Illinois Tollway Base Sheet Revisions
--

Section M	Base Sheet Drawings	
Drawing	Modification Summary	Effective: 2019-03-01
Pole Assembly (ITS)-Series 1000		
M-ITS-1000	Elevation Views Pole Mounted ITS Element Assembly Changed disconnect switch to unfused.	
M-ITS-1003	ITS Concrete Service Pad (2 sheets) New drawing with three types of service pads for ITS poles for flat and slope installation.	
M-ITS-1004	Cabinet Wiring Diagram - ITS Pole Mounted Enclosure (Solar Powered MVDS) (2 sheets) New cabinet layout separating ITS enclosure and dedicated co-located solar generator/battery cabinet with four 6 V batteries.	
Dynamic Message Sign (ITS)-Series 1100		
M-ITS-1108	DMS Cabinet Wiring Diagram Changed to Cisco 4000 series switch. Changed IP Relay to DIN IV.	
Cabinet Wiring (ITS)-Series 1200		
M-ITS-1200 to M-ITS-1217	Cabinet Wiring Diagrams 18 new ITS enclosure drawings replace old 56 ITS enclosure drawings for clarification. Drawings 1200 to 1217 have been redone completely. Consolidated equipment configurations. Standardized to-scale equipment layout. Changed to Cisco 4000 series switch. Eliminated 24 VAC transformer and 24 VAC CCTVs. Additional 24 VDC power supply. Cat6 Ethernet sur

BASE ATTACHMENT DETAIL
17 1/2" BASE DIA.

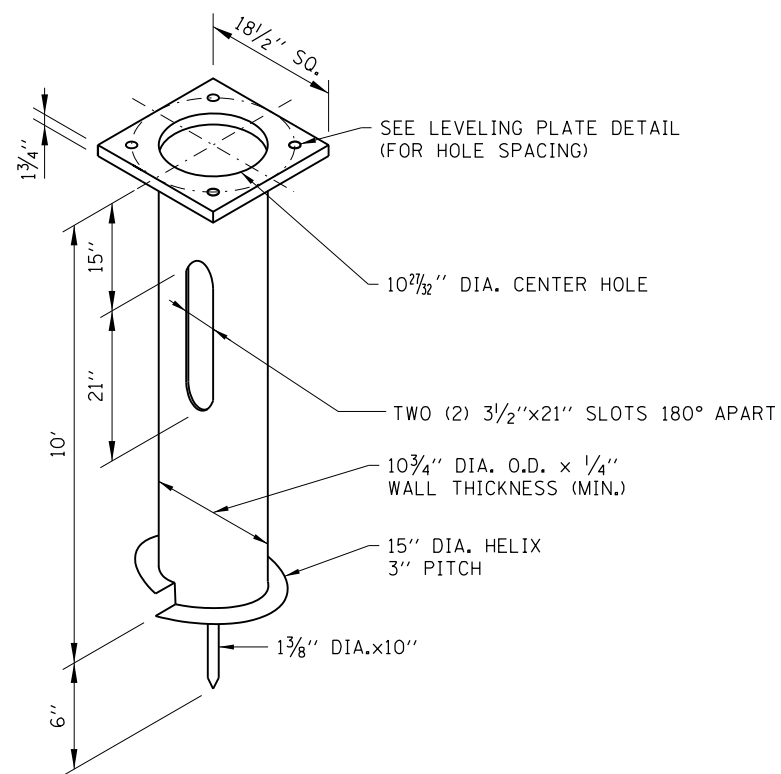
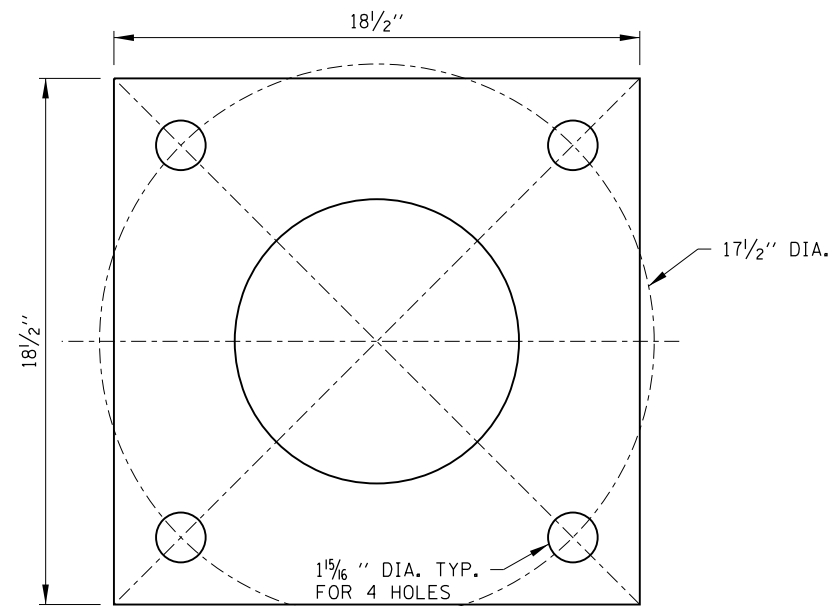
M-ITS-12018 to M-ITS-1255	Cabinet Wiring Diagrams Retired due to consolidation.	
Roadway Weather Information System (ITS)-Series 1300		
M-ITS-1300	RWIS Pole, Sensor Mounting Detail Pole height changed to 50 feet as standard pole for ITS with 17.5 inch bolt circle.	
M-ITS-1301	RWIS Cabinet Wiring Diagram Changed to Cisco 4000 series switch. Not connected to RWIS controller, for future use. Added IP Relay. Disconnected, for future use. Added secondary sensor pole cabinet wiring diagram. Cabinet is part of the design but was omitted in last year release.	
M-ITS-1303	Typical RWIS Grounding Schematic New drawing showing RWIS grounding system with grounding cable.	
Solar Powered Generator (ITS)-Series 1400		
M-ITS-1402	Pole Mounted Solar MVDS Assembly Co-located solar generator cabinet redesigned as M-ITS-1004.	
Tower Mounted CCTV (ITS)-Series 1500		
M-ITS-1500	Tower Mount Camera Details Cameras shown at offset height to avoid view obstruction. Pole mounting arm revised to Axis Q6155-E IP camera.

ALL NEW 50 FT. STEEL ITS POLES REQUIRE A 17 1/2" DIA. BOLT CIRCLE. SHOULD A 15" DIA. BOLT CIRCLE BE REQUIRED, THE DSE SHALL REFERENCE ILLINOIS TOLLWAY STANDARD DRAWING HI (LIGHT STANDARD FOUNDATION).
